Air Quality Technical Note Hampstead Police Station 4<sup>th</sup> September 2019 AQ106285c1

# 1.0 – AIR QUALITY TECHNICAL NOTE - PRIMARY SCHOOL AT THE FORMER HAMPSTEAD POLICE STATION (2019/2375/P)

Plate 1 – Diffusion Tube Col-locations with Camden monitoring station

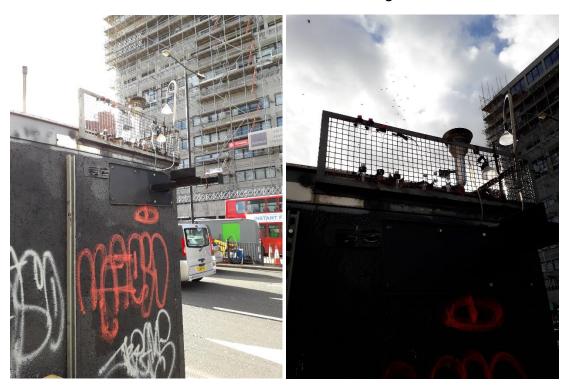
Photos of the diffusion tubes were provided of the monitors at the development site but not for the co-location at the Camden Kerbside Automatic monitoring station. The co-located diffusion tubes seem to be in close proximity to a bus stop which could affect the readings. From the map evidence provided this co-location is not suitable to provide an accurate Bias adjustment factor. Action: Further evidence of the co-location tubes required. If not within 1m of the inlet of the automatic monitoring station the results are not considered valid. Further information required.

The colocation monitoring station used for bias adjustment was the closest automatic site, Camden Kerbside (located at NGR: 526633, 184390) approximately 1.1km south of the development site as indicated in 'Figure 2 within Appendix II'. There appears to be an error in the report and two, 'Figure 2' have been presented. The second 'Figure 2', referred to by the Sustainability officer is not relevant for this project and should be disregarded, we apologise for any confusion that may of occurred. The

first 'Figure 2' is however correct and displays the correct location of the Camden monitoring station used for co-location.

With regards for evidence of co-location please Plate 1 for images of the collocated diffusion tubes. It should be noted that there are several sets of diffusion tubes at the station as it appears to be used frequently for co-location. If is further noted that Camden was contacted with regard to the suitability of using this location and no objections were raised.
